Re: Kings House School Strawberry Tree

Further to you request that I consider the pruning required to a Strawberry tree (TPO ref T23, tree survey number T19) to allow construction access, I visited site on 24-11-2021 am now pleased to attach some marked up photos and to provide my comments.

Kings House School A

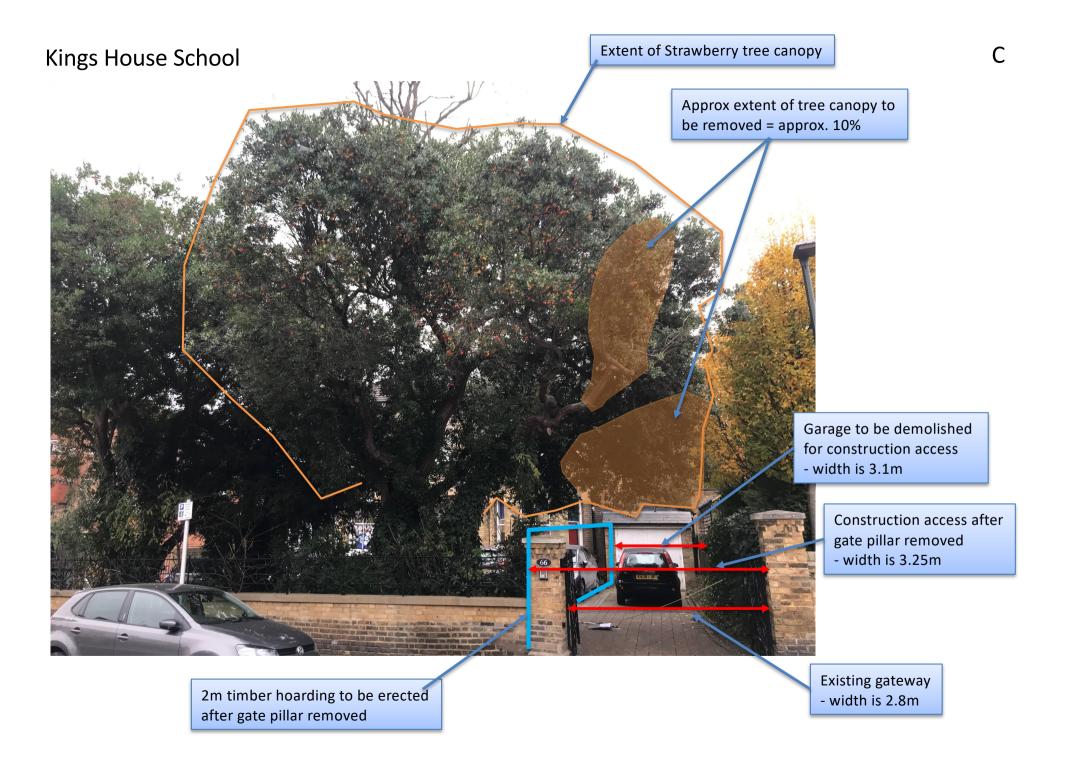
- a 110mm diameter branch above the gate pillar, shown on photo page A attached, which will need to be taken back to the fork indicated "X" on the photo. This is a significant branch but only supports a small amount of foliage, as indicated.
- a 130mm low hanging branch, shown on photo page B attached, further back in the site, which will need to be taken back to the fork as indicated on the photo. This is a significant branch which supports the majority of low foliage to be removed.
- a 50mm low hanging branch pruned to point "Y" on the photo.
- 3no small low hanging branches between the two larger branches described above, with diameters of approximately 15mm, 25mm and 35mm.

To protect the tree from construction traffic, timber "goal posts" must be erected to protect the major branches at points "X" and "Y". Sheet D attached shows the dimensions of these "goalposts" relative to these points. Erection of "goal posts" should be specifically included in tender documents and they should be inspected by a retained arboricultural consultant before this access is used for demolition of the garages.
